**BOARD OF ZONING ADJUSTMENT
STAFF REPORT****Date: August 4, 2014****CASE NUMBER**

5905

Rangeline Business Park, LLC

VARIANCE REQUEST

SITE PLAN

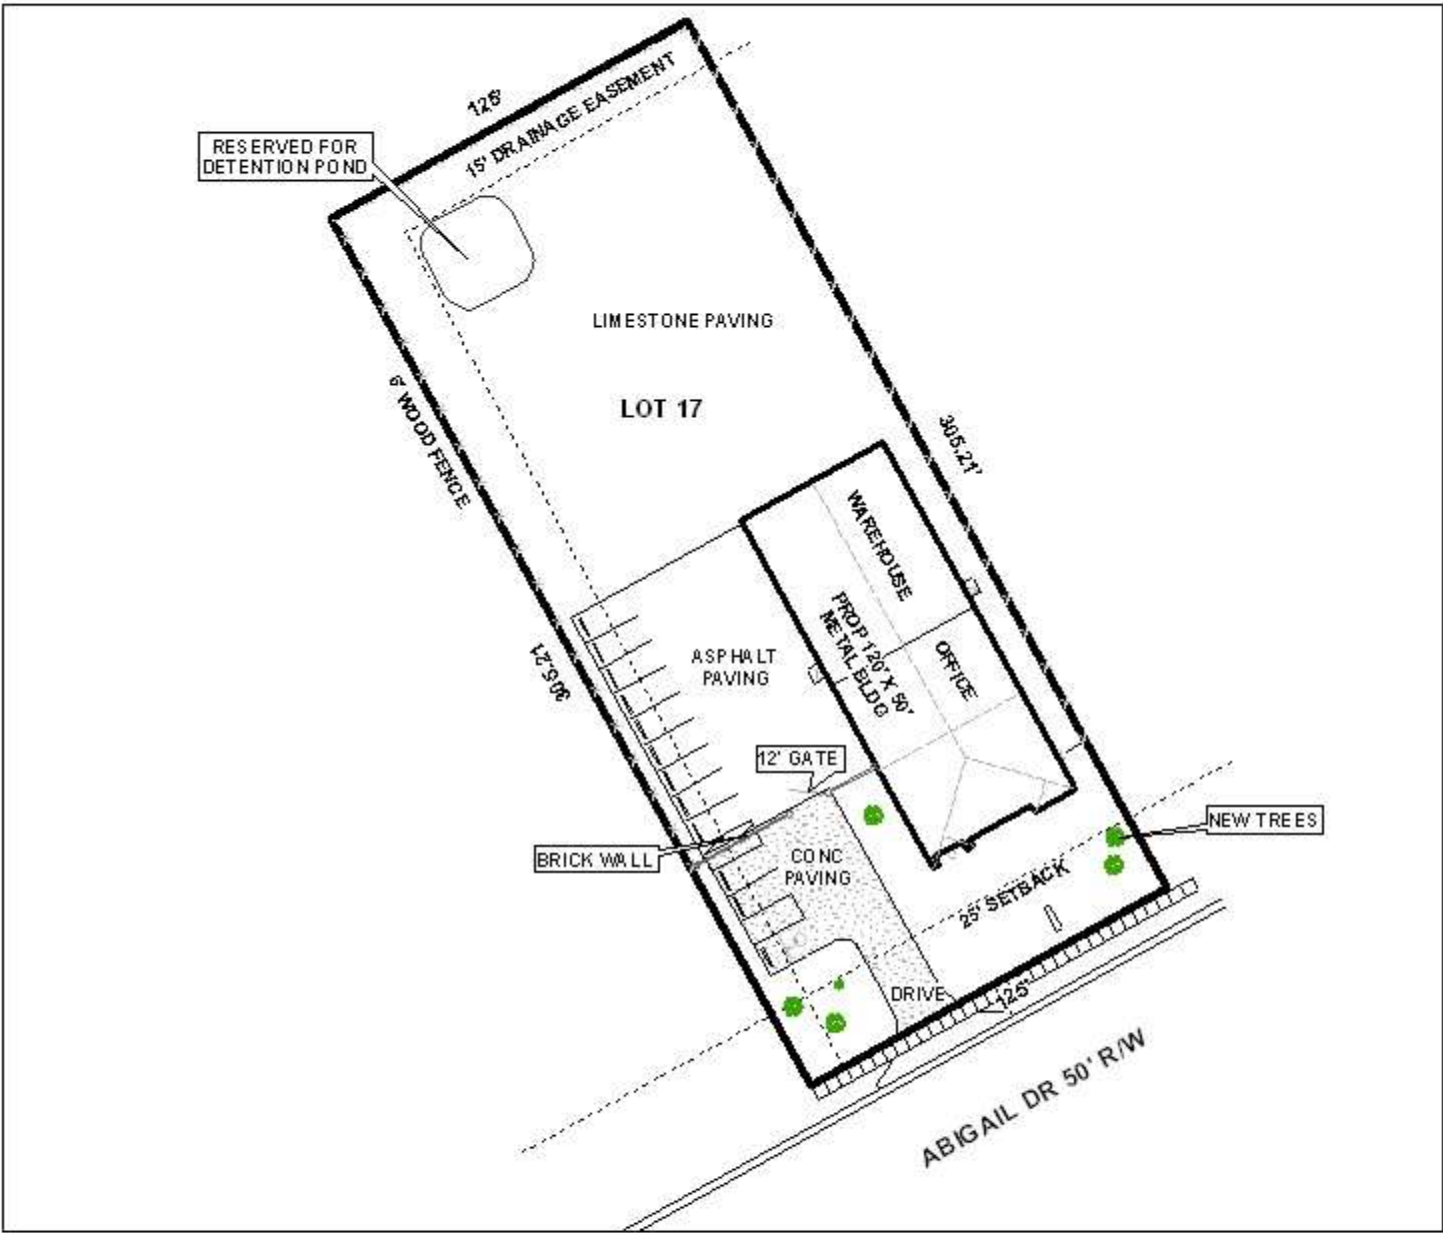
The minimum width that should be acceptable is 20', for both the driveway and the gate clearance. The maneuvering area, as illustrated on the site plan is 26' and exceeds the standard 24' requirement, therefore the maneuvering variance is not necessary.

Inasmuch as compliant site plans were initially approved for the development of the two adjacent sites previously mentioned, and the subject site is the same size and shape as those two, it would stand that the subject site could also be developed in compliance with the Zoning Ordinance. The site plan submitted is almost exactly the same as those of the previous two sites.

The applicant does not address the proposed 6’ high wooden privacy fence around the lay down yard in the narrative, and has not submitted a revised site plan indicating a compliant 8’ fence. As nothing appears on the site plan to indicate a hardship necessitating only a 6’ high fence and no justification for such is given, the granting of the request for such would be out of order.
